Addendum #2

RFP No. 6638

Title: Border-to-Border Trail River Terrace Bridge and Trail
Construction

Washtenaw County River Terrace Trail
Details

A BOARDWALK FRAMING PLAN
© 2011 by Conservation Design Forum, Inc

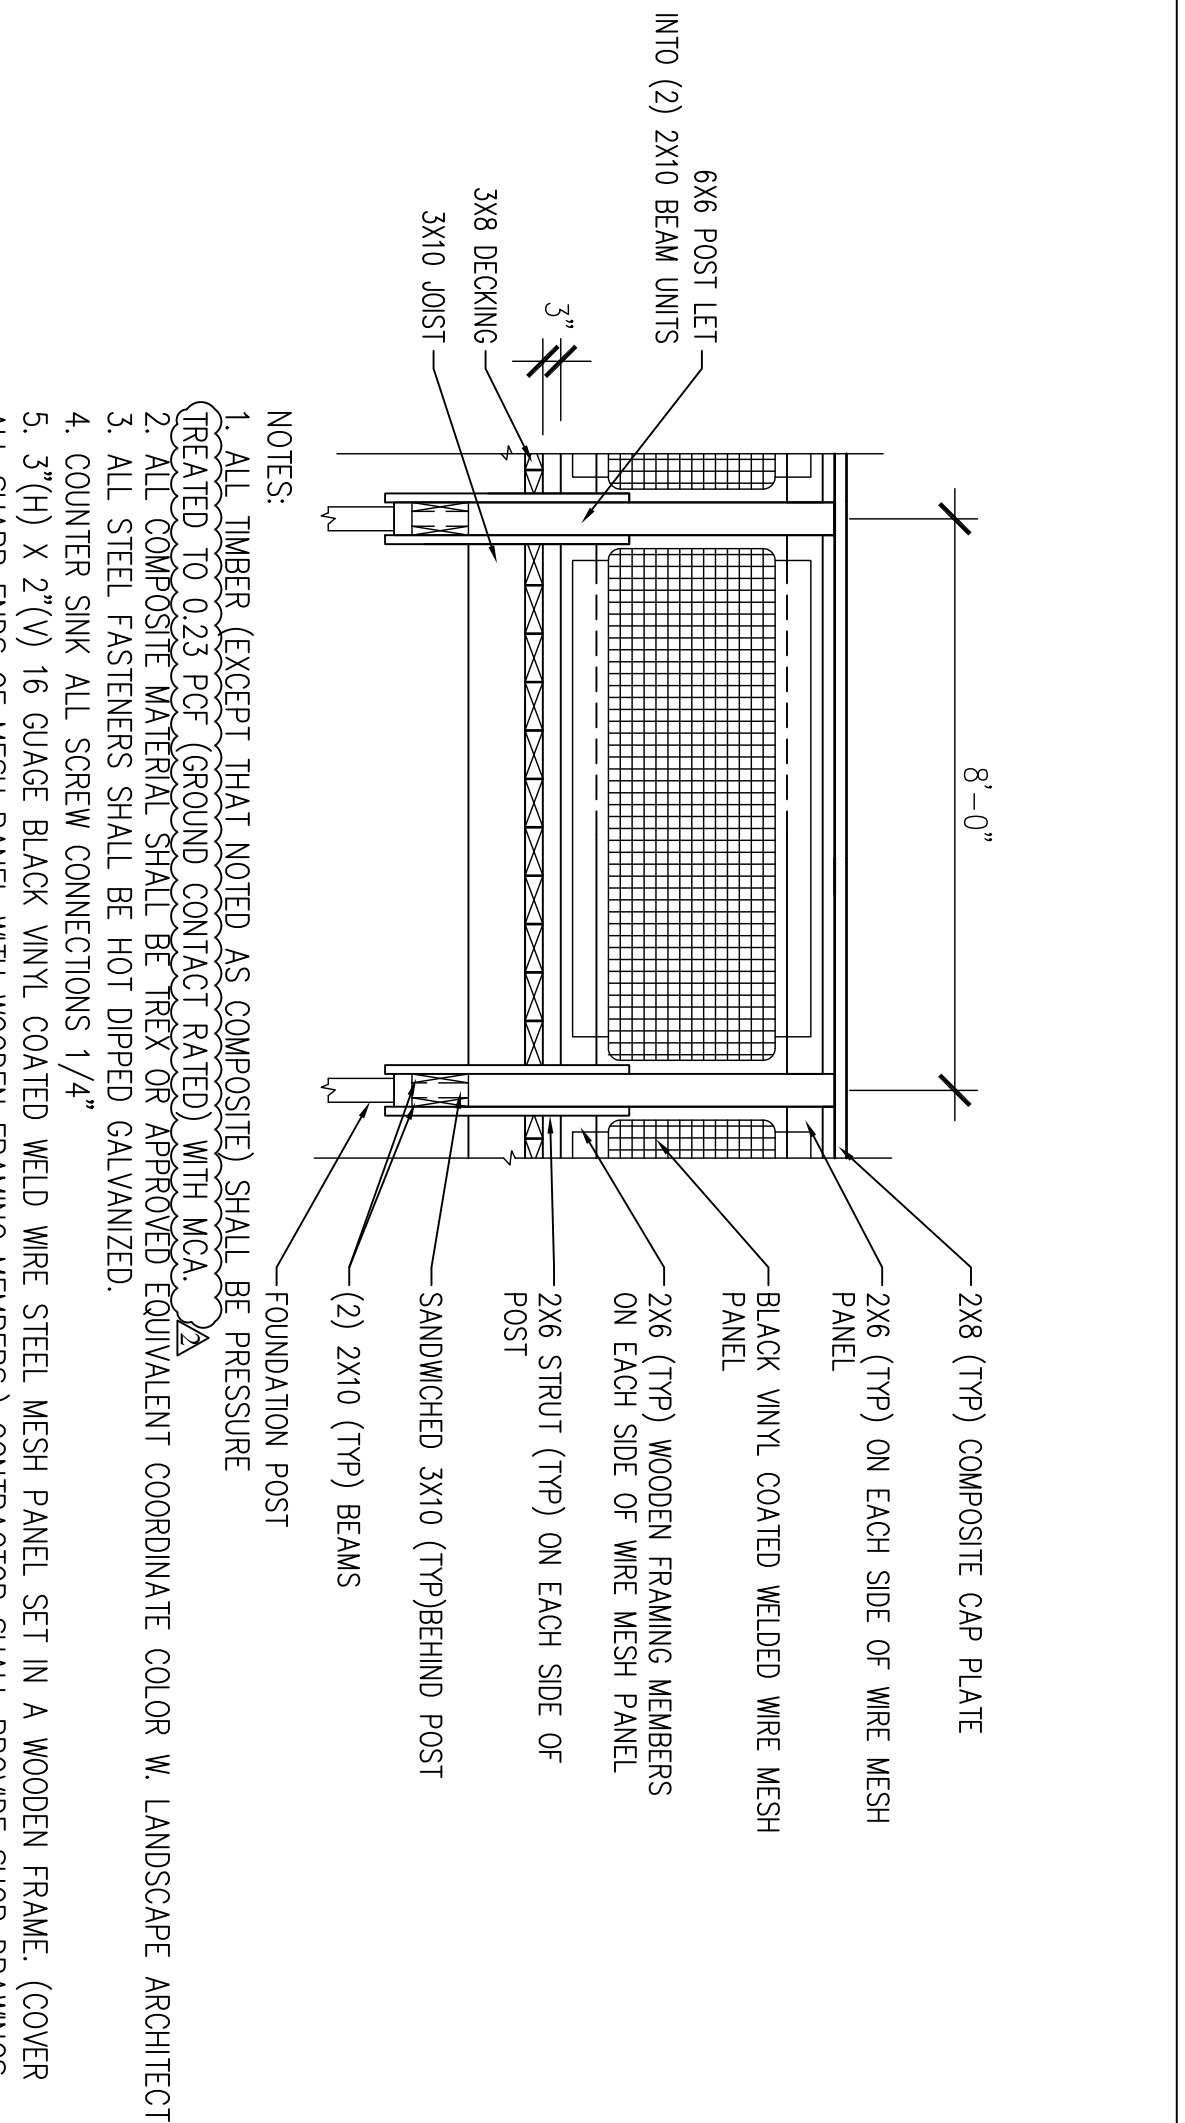
the plan says we want 3x8 decking for the boardwalk. Did we mean 1x8? Trex doesn't make a 3x8????? Please include this with your responses.

DECKING IS 3X8 WOOD MATERIAL. TREX PRODUCTS WILL BE ONLY ON CURBS AND CAPS OF RAILINGS.
